# Technical Service Bulletin

| <b>Subject:</b><br><b>RATTLE NOISE FROM FRONT SUSPENSION WHEN DRIVING OVER BUMPS</b> | <b>Bulletin No.:</b> 02-004/21 |
|  | <b>Last Issued:</b> 02/22/2021 |

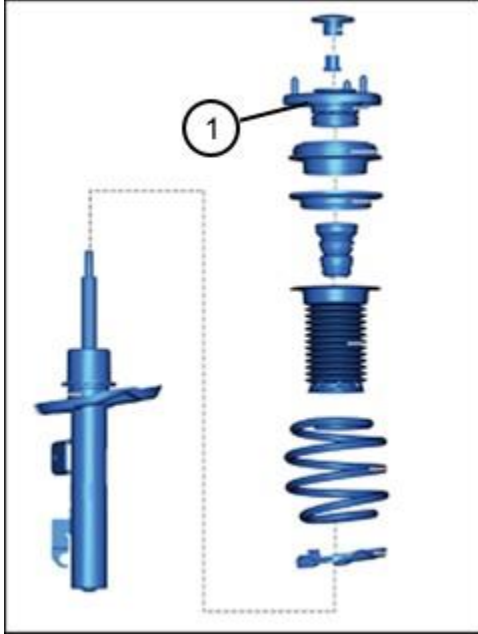
Some vehicles may exhibit a rattle noise from the front suspension when driving over bumps or on a road with a wavy surface. The noise may be caused by the mounting rubber (1) because of insufficient clearance between the rubber and the metal bracket of the mounting rubber during the assembly process. To correct this issue, the mounting rubber has been modified to ensure the proper clearance.

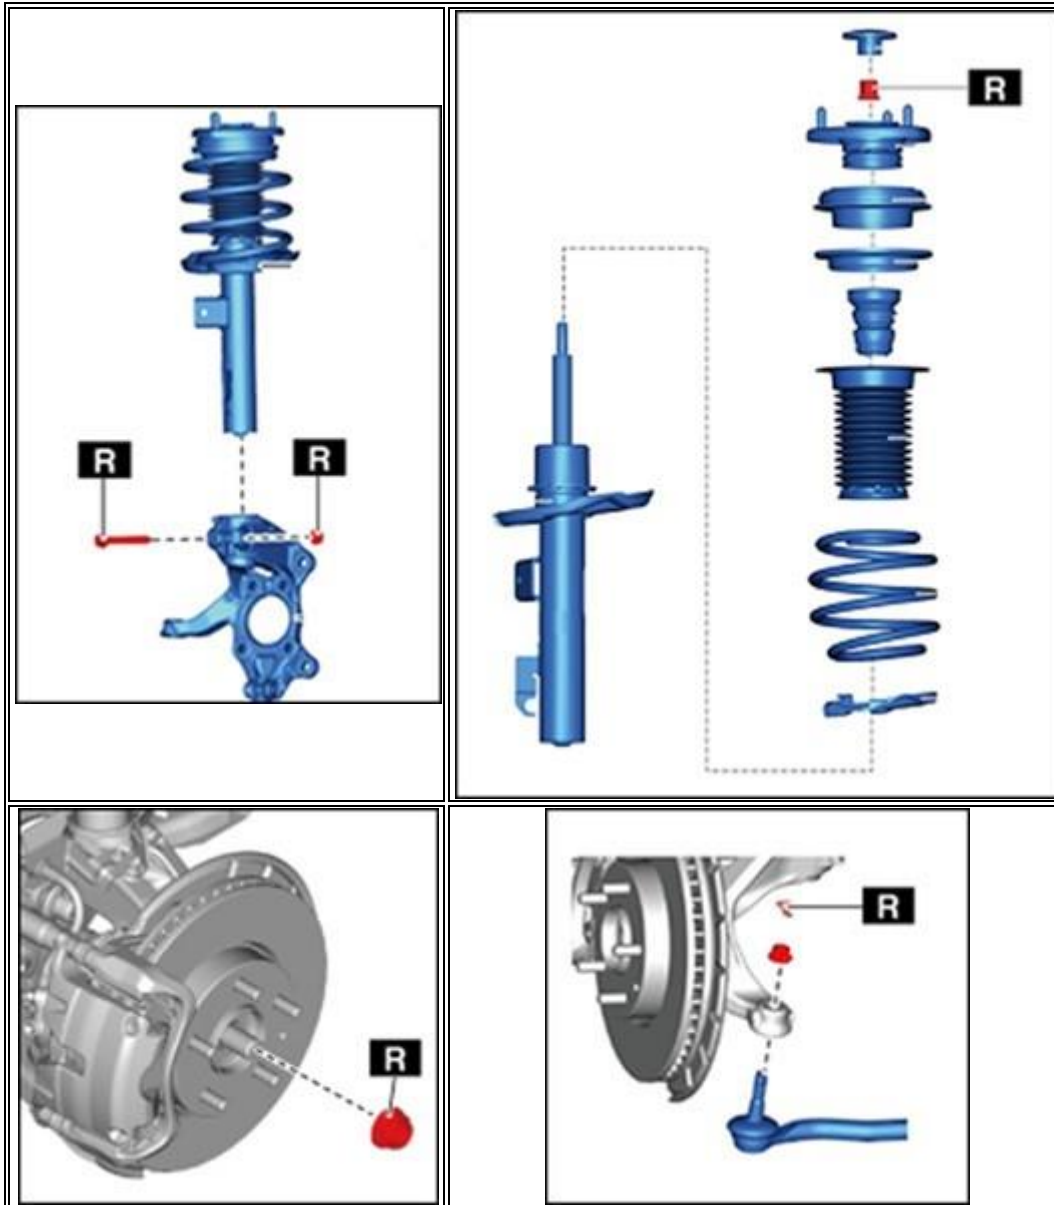
- Modified mounting rubber BCKE-34-380B is of the same part number as before, but with the production date stamped in white letters on the back of the part. The modification has been implemented from Nov. 21, 2019. Sample image shows back of the mounting rubber.
- BCKE-34-380C and BDTS-34-380B are modified parts regardless of the production date.
